ALAMEDA COUNTY  
HEALTH CARE SERVICES

July 3, 2007

Subject: Fuel Leak Case No. RO0000260 and Geotracker Global ID T0600101089, Plaza Car Wash, 400 San Pablo Avenue, Albany, CA 94706

Attachment: Sump Location Plan with Recommended Soil Boring Locations

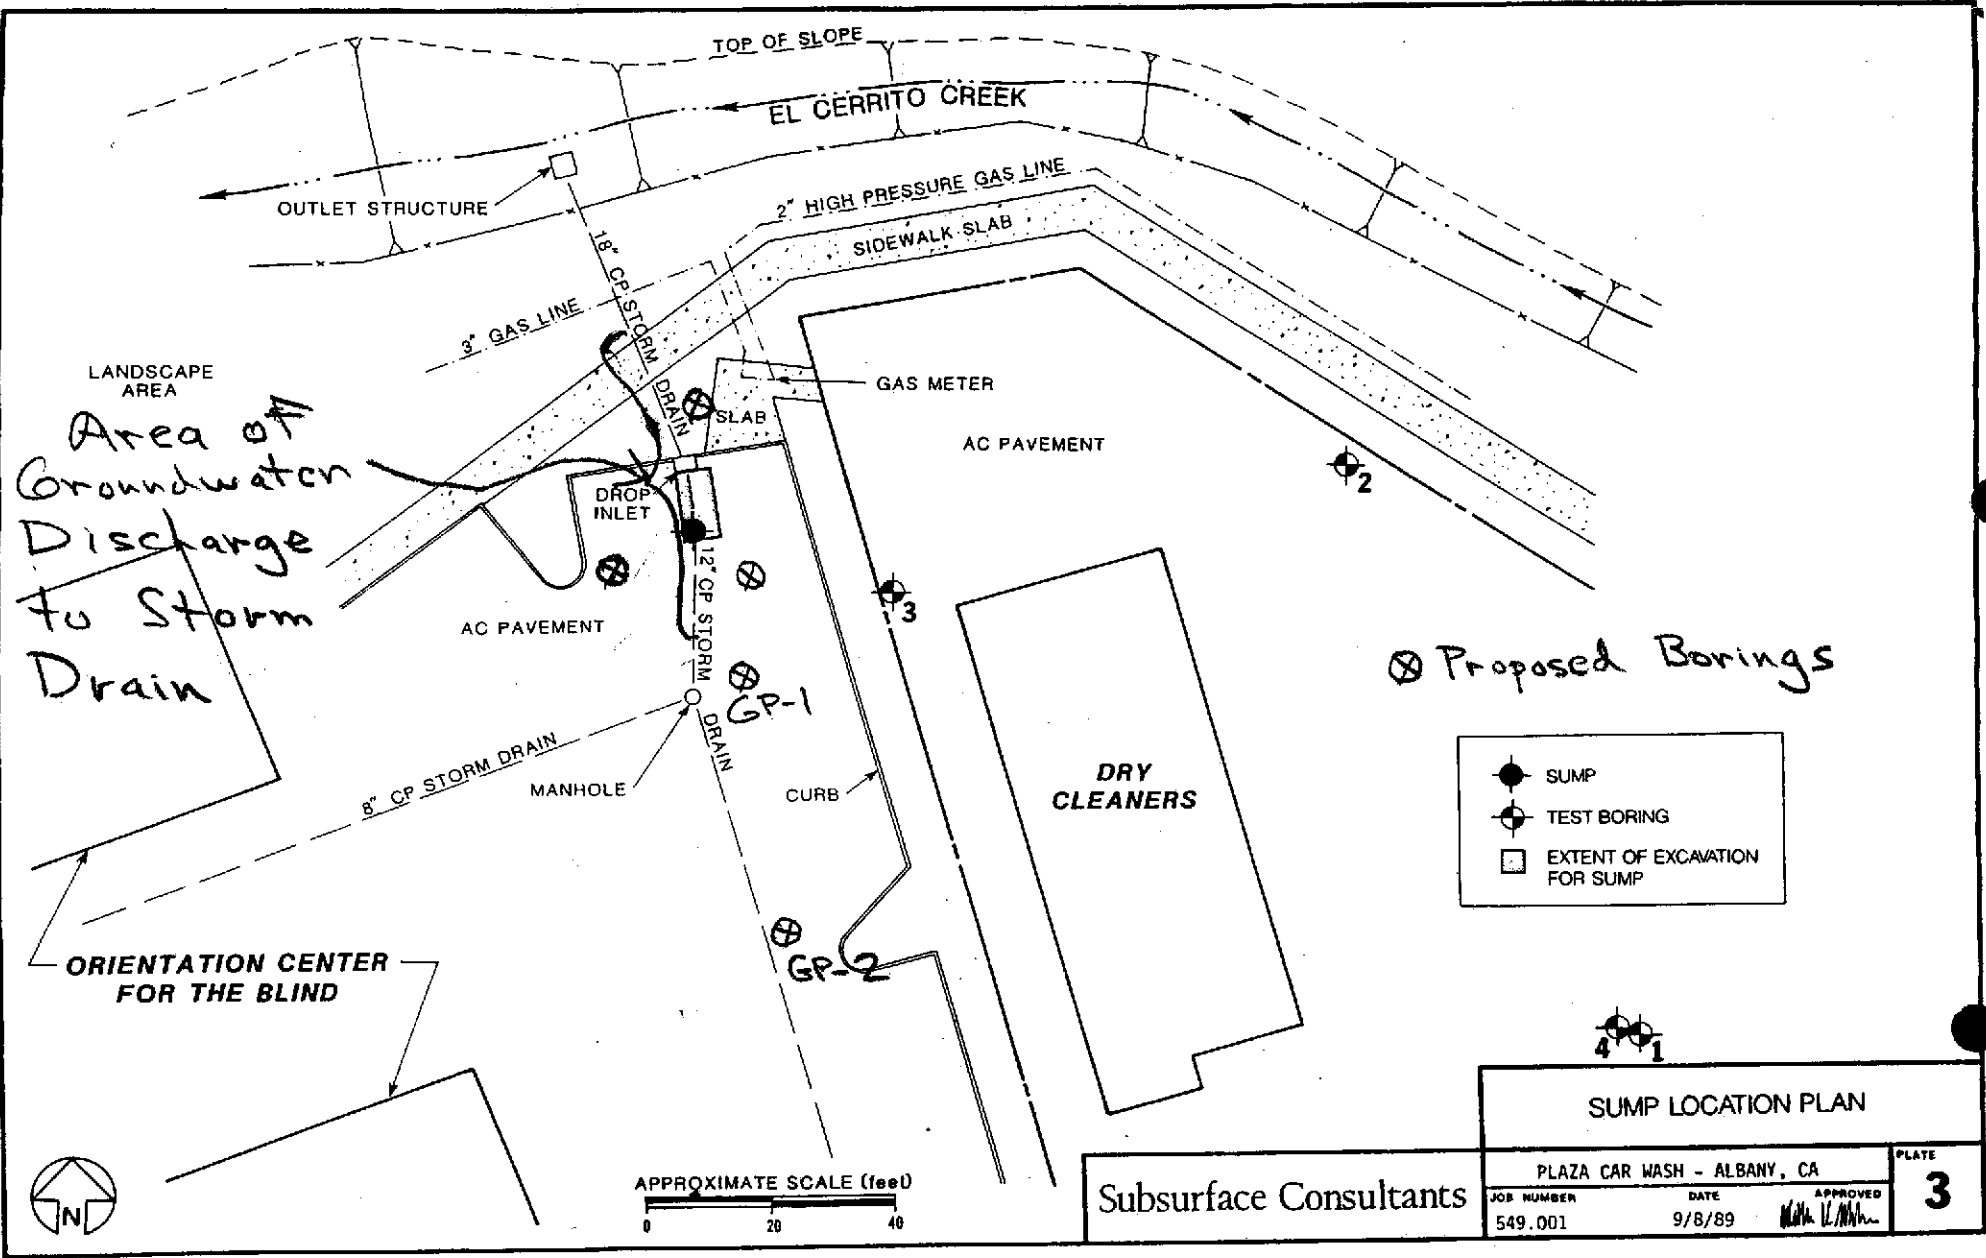
proposed investigation and during future groundwater monitoring. Please include plans to sample the sump in the revised Work Plan requested below.
